The Republic, Mayfield Manchester
Planning Addendum Report
0197_MAY-MCO-M01-XXXX-RP-A-090080
Rev: P03
Ref: A283-10.01-148
November 2024

1.0 Planning Addendum

1.1 Introduction

2.11 North Elevation

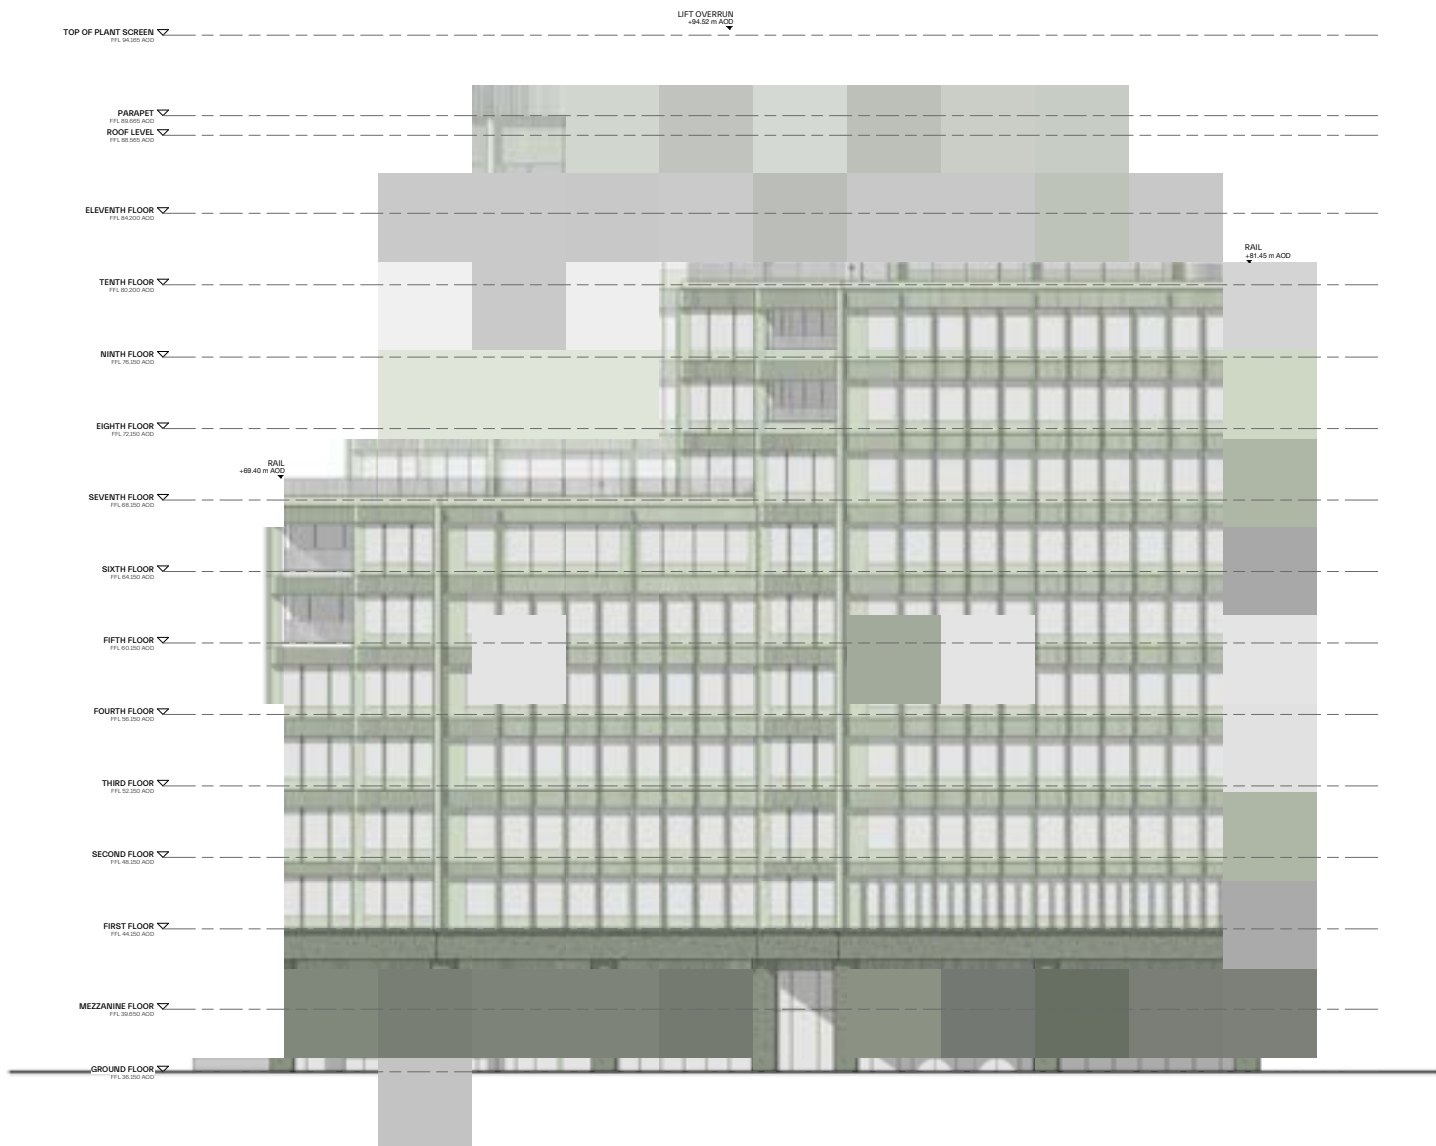
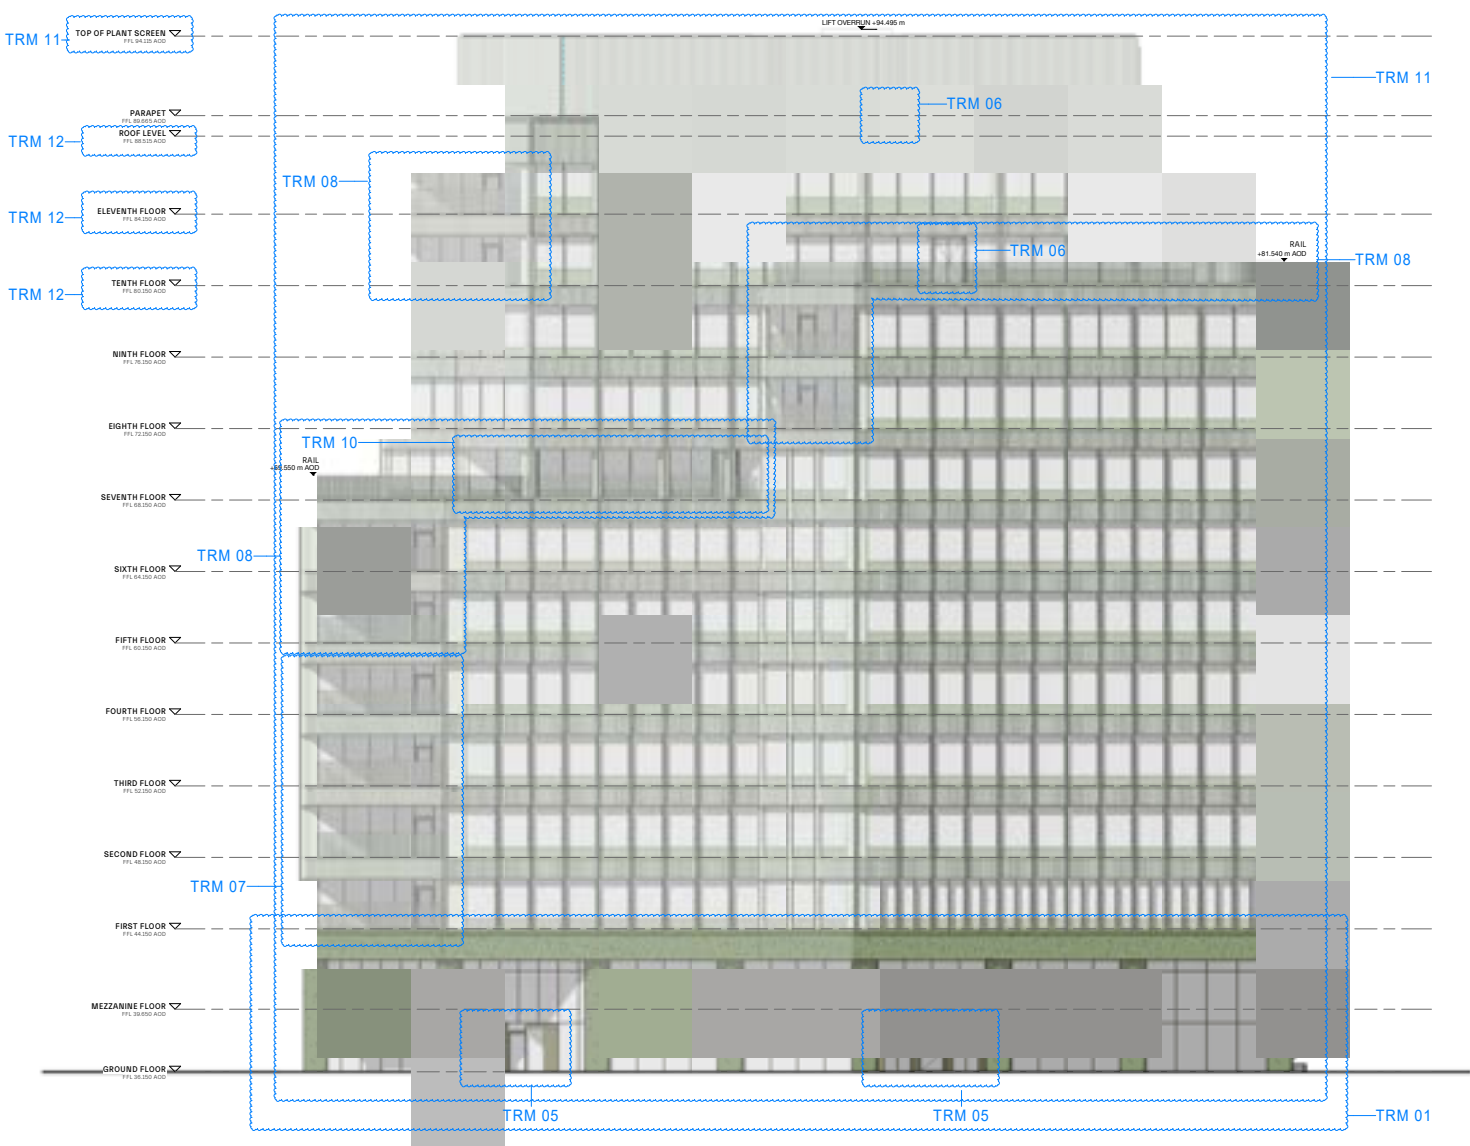
- + TRM 01 - Structural Grid
- + TRM 12 - FFL
- + TRM 05 - Ground Floor Entrance
- + TRM 06 - External Doors
- + TRM 07 - Loggia
- + TRM 08- External Amenity Spaces
- + TRM 09 - Massing to North
- + TRM 10 - External Columns
- + TRM 11 - Facade Development

2.12 East Elevation

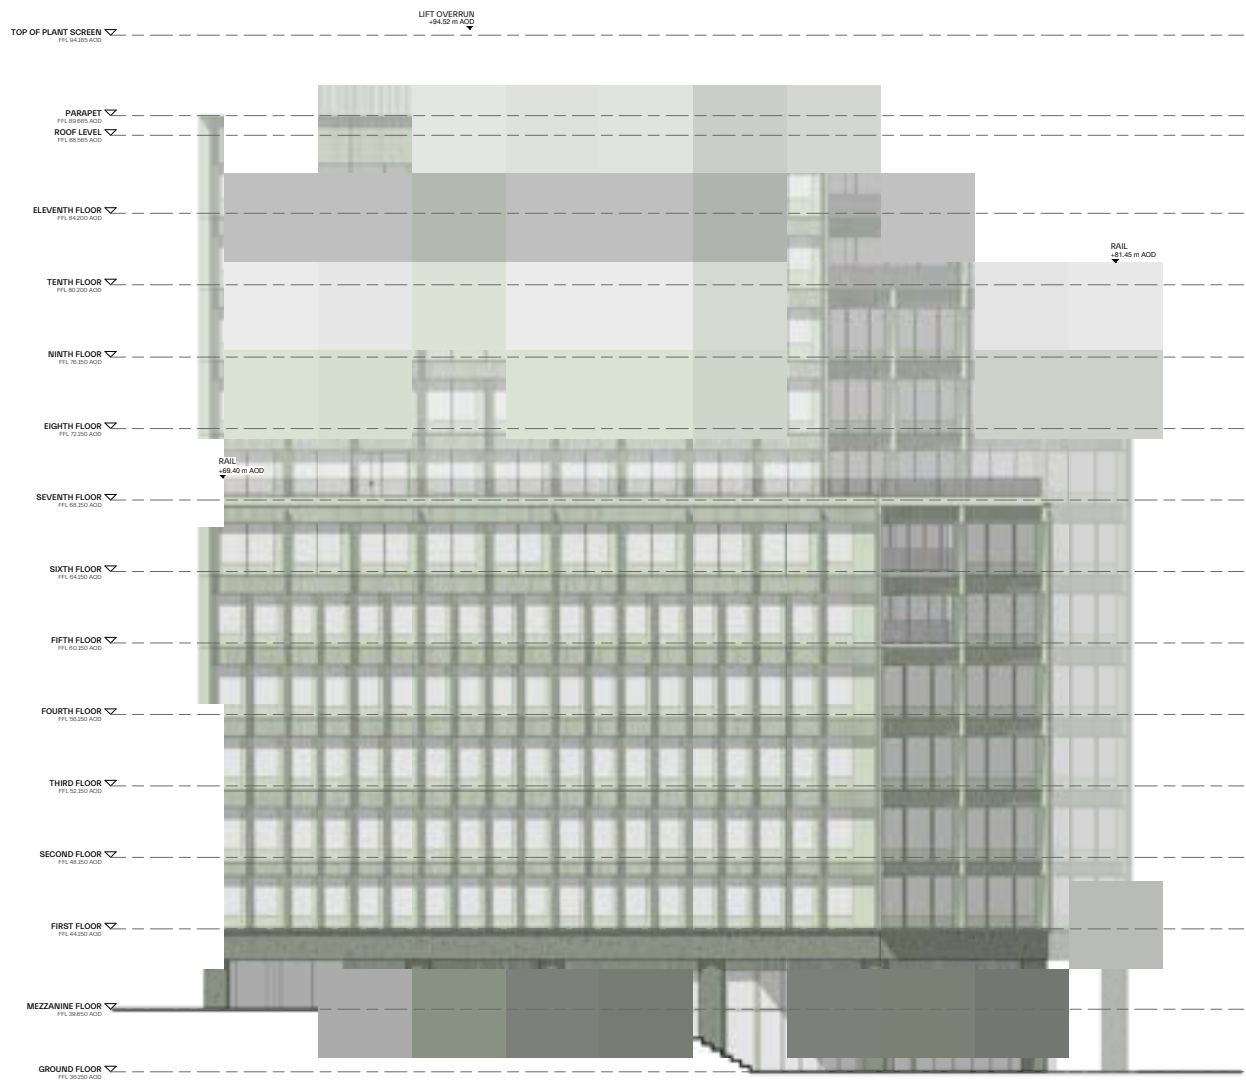
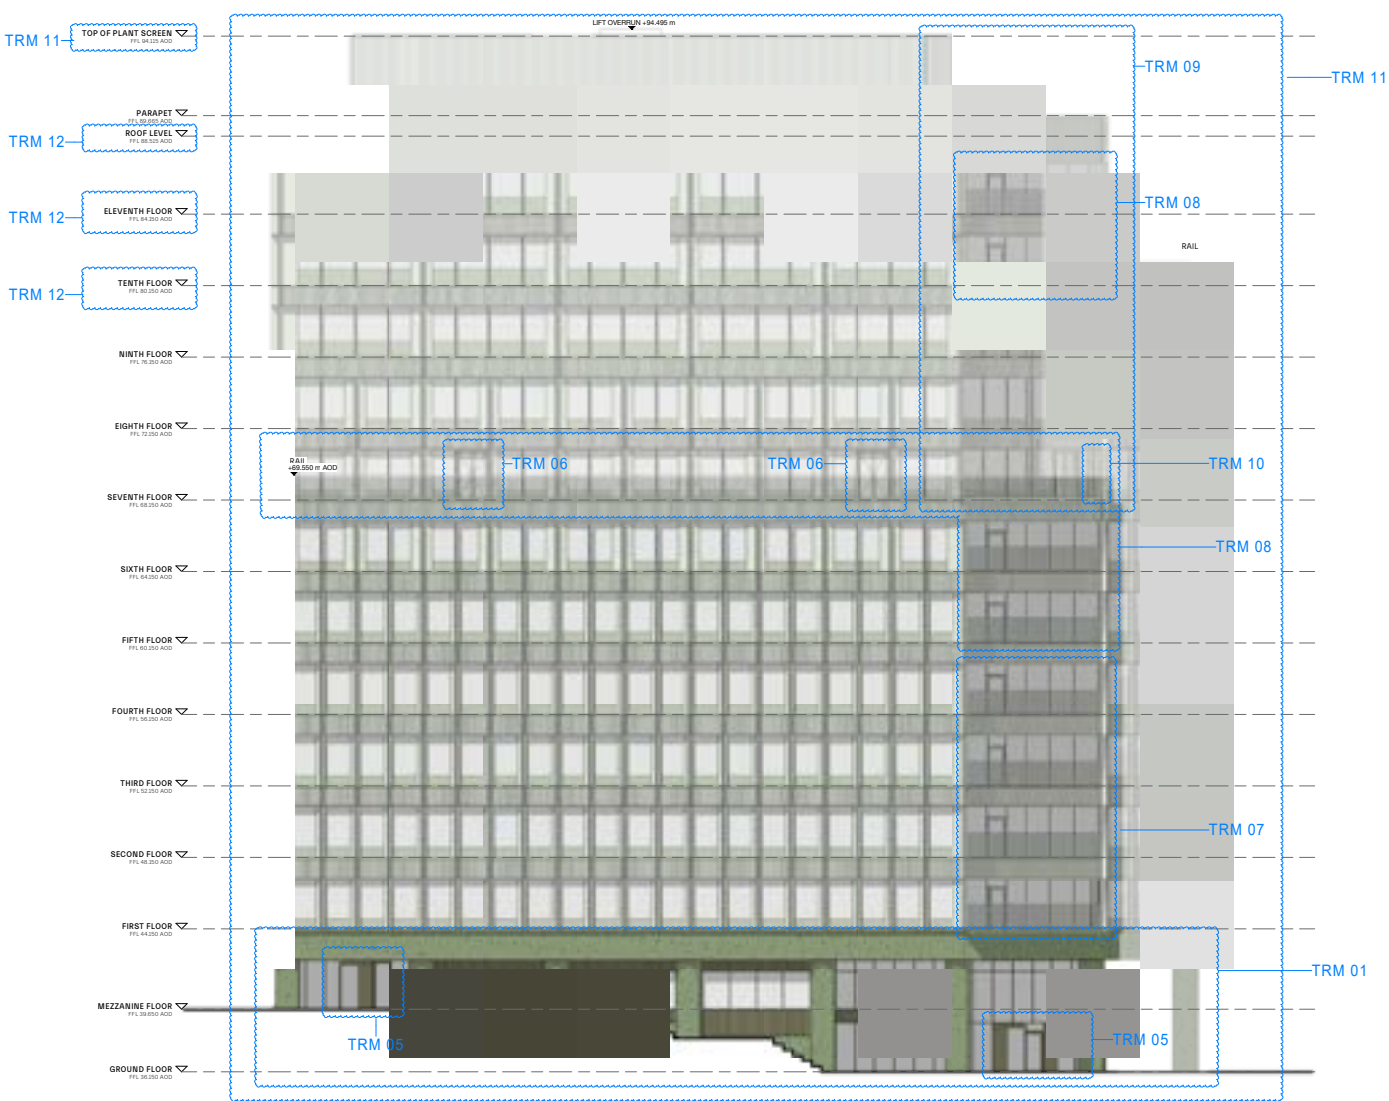
- + TRM 01 - Structural Grid
- + TRM 12 - FFL
- + TRM 05 - Ground Floor Entrance
- + TRM 06 - External Doors
- + TRM 07 - Loggia
- + TRM 08- External Amenity Spaces
- + TRM 09 - Massing to North
- + TRM 10 - External Columns
- + TRM 11 - Facade Development

2.13 South Elevation

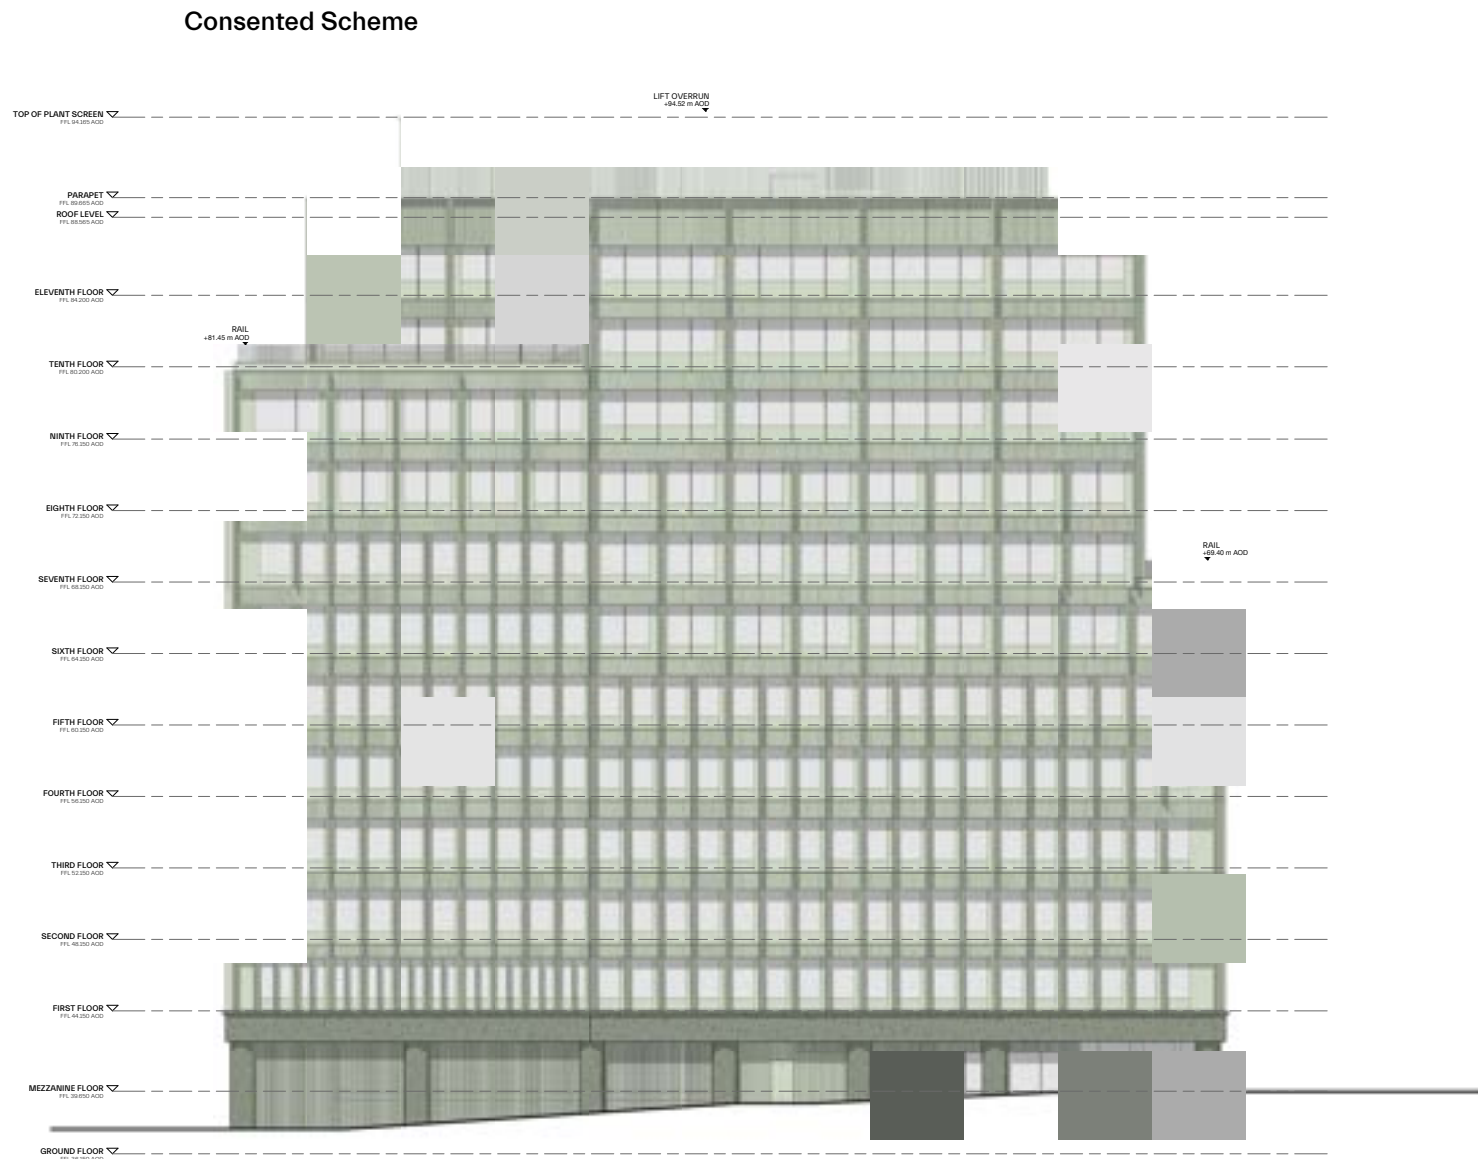
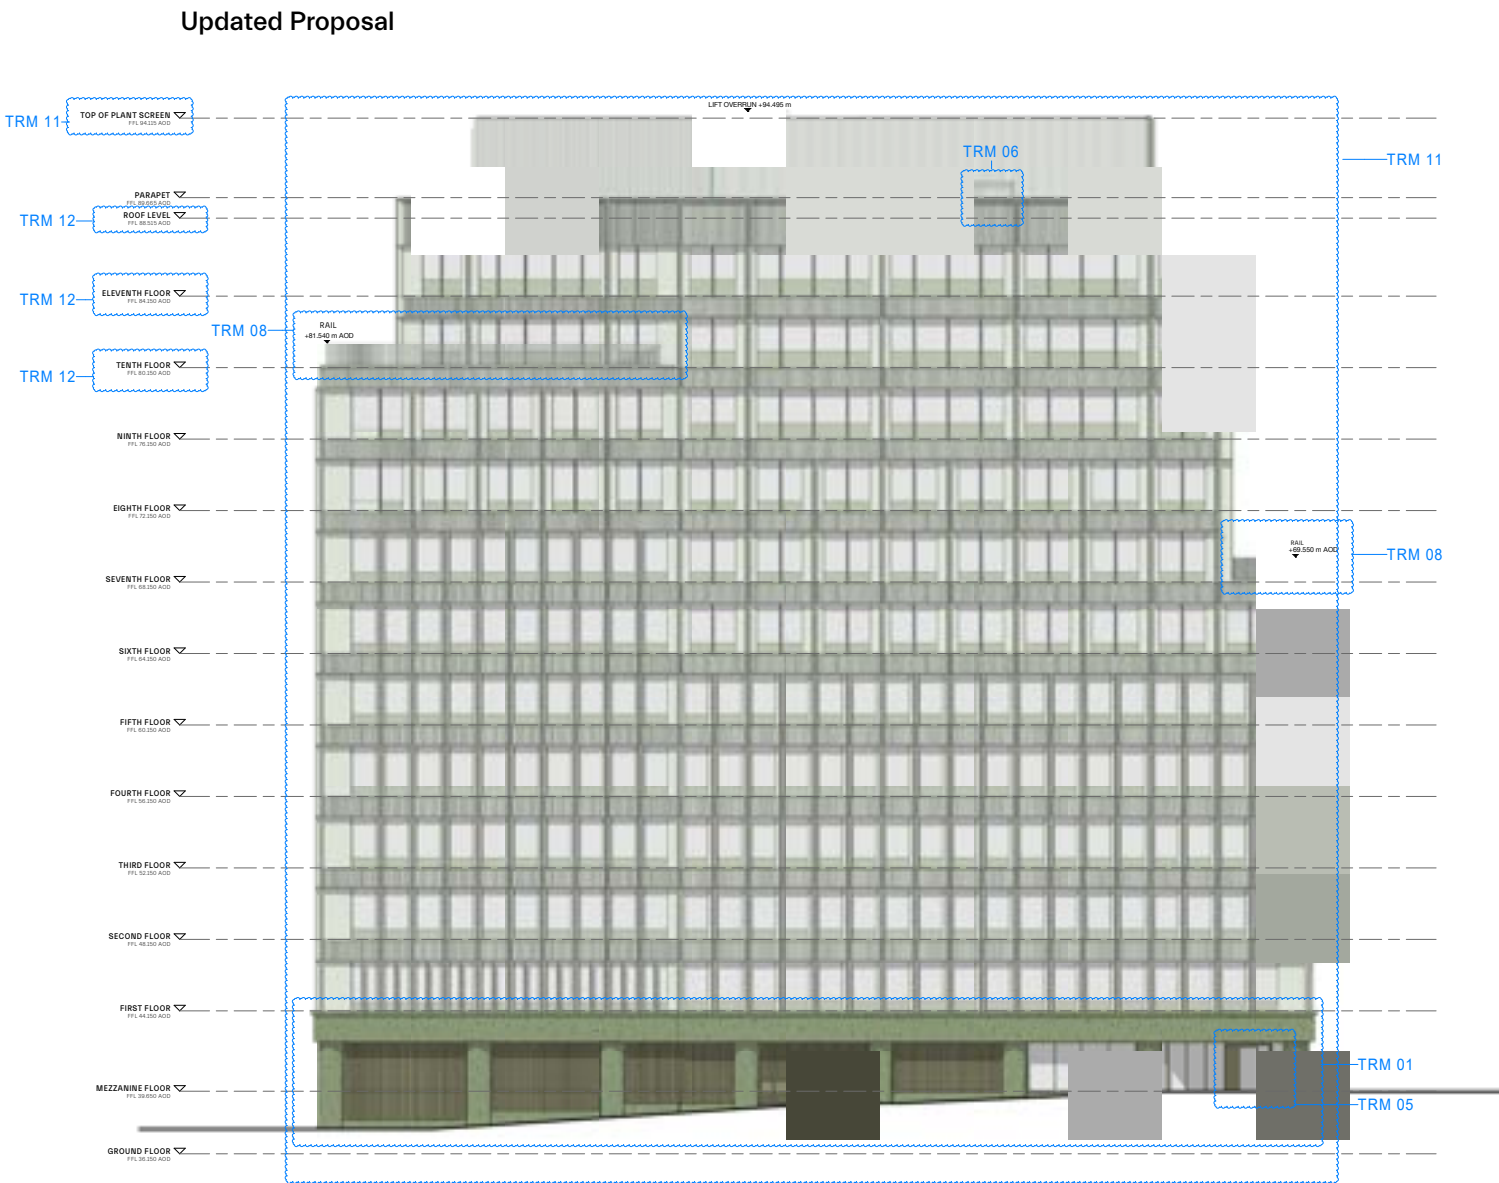
- + TRM 01 - Structural Grid
- + TRM 05 - Ground Floor Entrance
- + TRM 06 - External Doors
- + TRM 08- External Amenity Spaces
- + TRM 09 - Massing to North
- + TRM 11 - Facade Development
- + TRM 12 - FFL
